## BULLETIN

# SWAY BAR LINK FAILURE

2007-2009 MAZDA 3  
2007-2009 MAZDASPEED 3

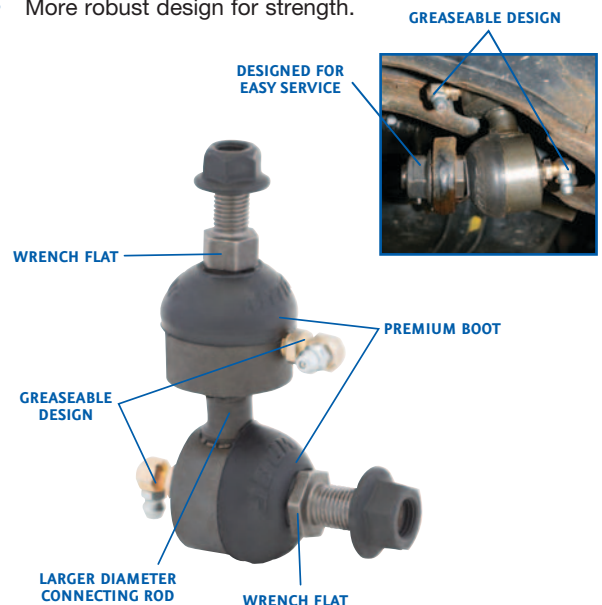
Owners of the popular Mazda 3 may complain of rattling and/or clunking from the rear end of their vehicles. This may be caused by a failed sway bar link.

The OE part is a non-greaseable, plastic socket design and is prone to premature wear. This results in a rattling and clunking noise from the rear of vehicle. Also, the OE replacement part is often damaged during installation: Since wrench flats are not incorporated into the design of the OE replacement part, installers will sometimes use an air wrench to install it. Unfortunately, the friction generated by allowing the stud to spin within the plastic socket may cause irreversible damage.

The MOOG<sup>®</sup> problem-solving K750069 sway bar link provides ease of installation for the technician and improved, long-term performance for the vehicle owner.

- Durable, all-metal, greaseable construction is not prone to OE plastic design failures.
- Greaseable to reduce friction and flush out contaminants.
- Convenient, easy-access wrench flat allows the use of socket for easy installation.
- All-metal "gusher" bearing design allows lubricant to penetrate bearing surfaces for longer life.
- Premium polychloroprene boots resist tears and splitting.
- More robust design for strength.
